CERTIFICATE OF APPROPRIATENESS

Property: 1233 Rutland Street, lot 4, block 183, Houston Heights Subdivision. The property consists of a one-story single-family residence situated 6,600 square foot (50' x 132') interior lot.

Proposal: Alteration – Window, Revision to existing COA

HP2021_0289

CURRENT PROPOSAL
Proposed Northern Side View with New Window

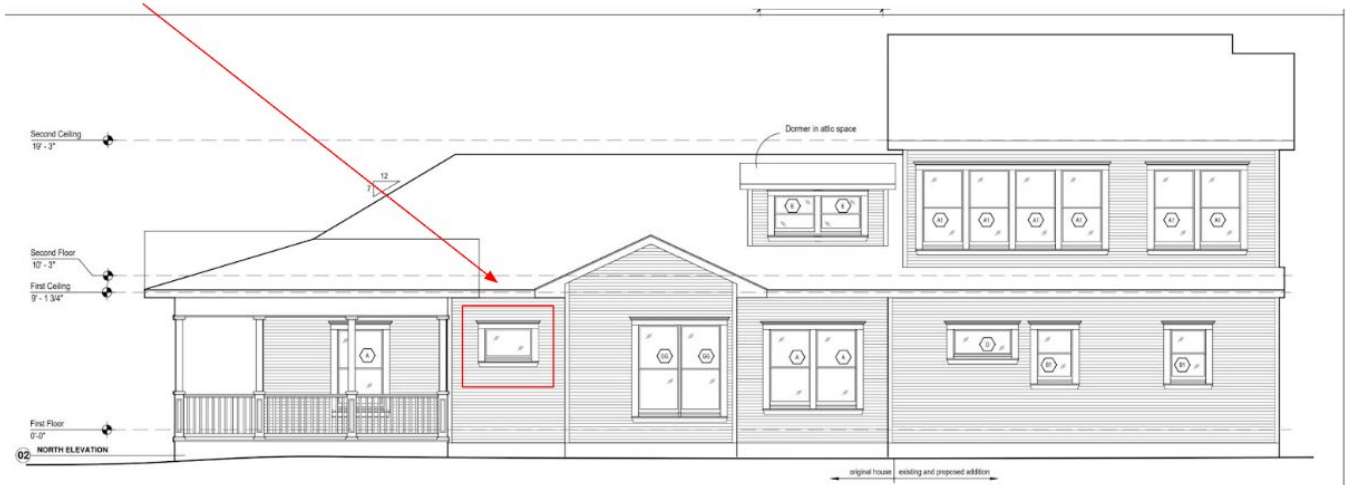
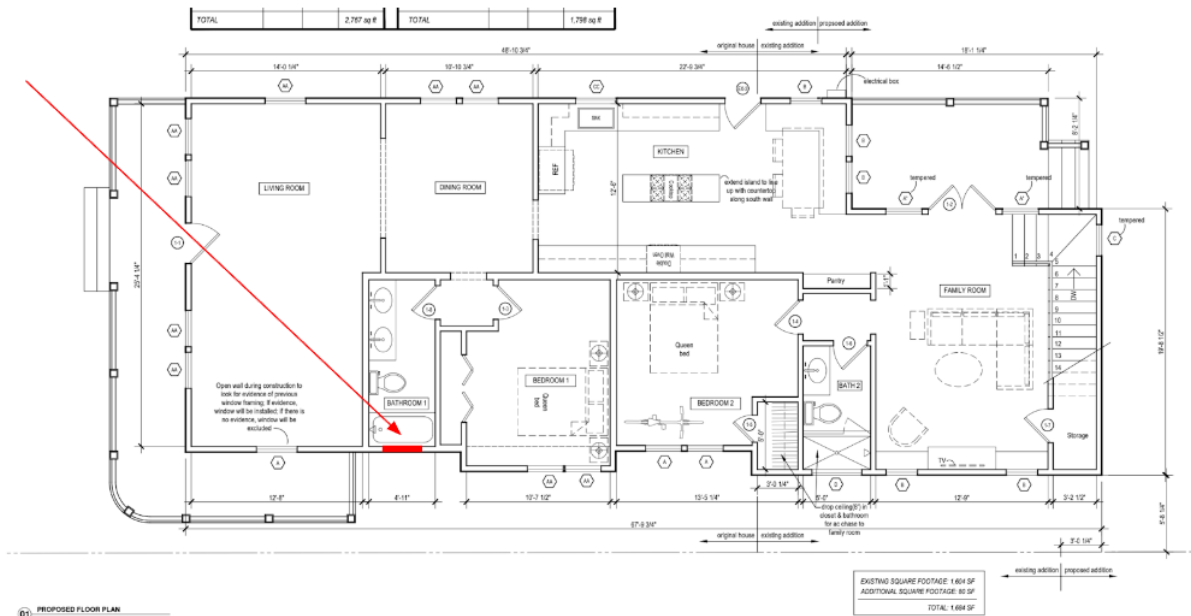
<i>Type and material of the proposed awning window are not compatible with character of the property.</i> |

Add a window to the first floor bathroom. During construction, we discovered a window frame under the sheet rock in the bathroom. Knowing that there used to be a window there, we are requesting permission to bring the room closer to its original state by adding a new window. We propose adding a window that is the same width as the other windows throughout the house (32"). Here is a slide deck showing the location of the bathroom, the wall in question, and the proposed window:

- *Addition/Alterations previously reviewed by HAHC 11/17/21, HP2021_0289*
- *HAHC action: Approval with conditions: that the north facing window in the front room can't be opened until staff verifies during construction that there is proof of that windows opening's existence. Staff member Arslan confirmed this opening is approved.*
- Revision includes new opening on south side elevation, located towards the front.
- Interior framing shows evidence of full-size window (see interior photo), most likely 35-3/8" W x 64"
- Applicant proposes 32.75" x 18" vinyl awning window in the location.
- **Information subject to change before final report**

NORTH SIDE ELEVATION
EXISTING

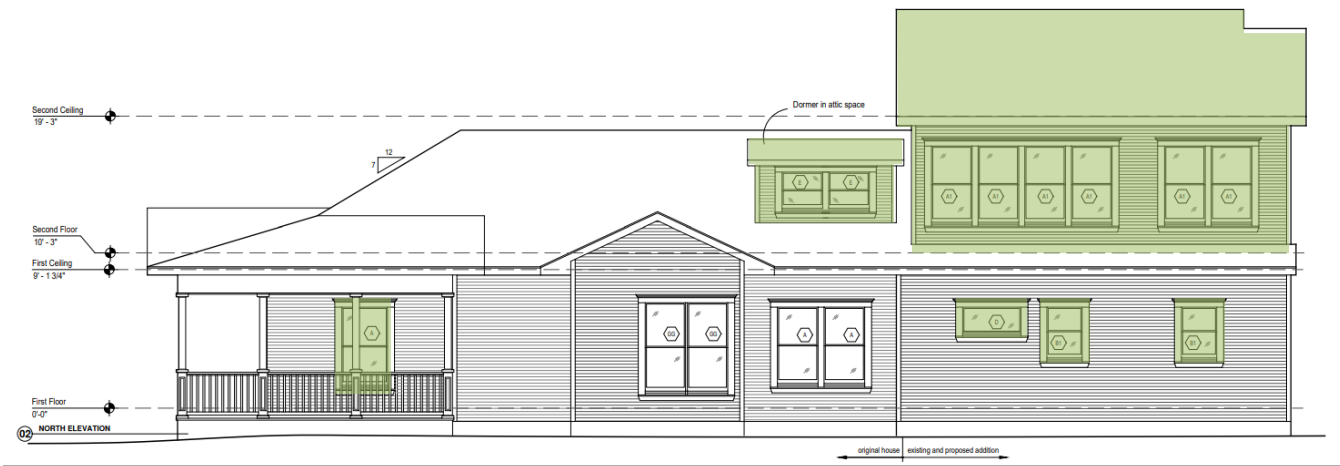
Recommendation: Approval with conditions: that the north facing window in the front room can't be opened until staff verifies during construction that there is proof of that window opening's existence.

HAHC Action: Approval with conditions: that the north facing window in the front room can't be opened until staff verifies during construction that there is proof of that window opening's existence.
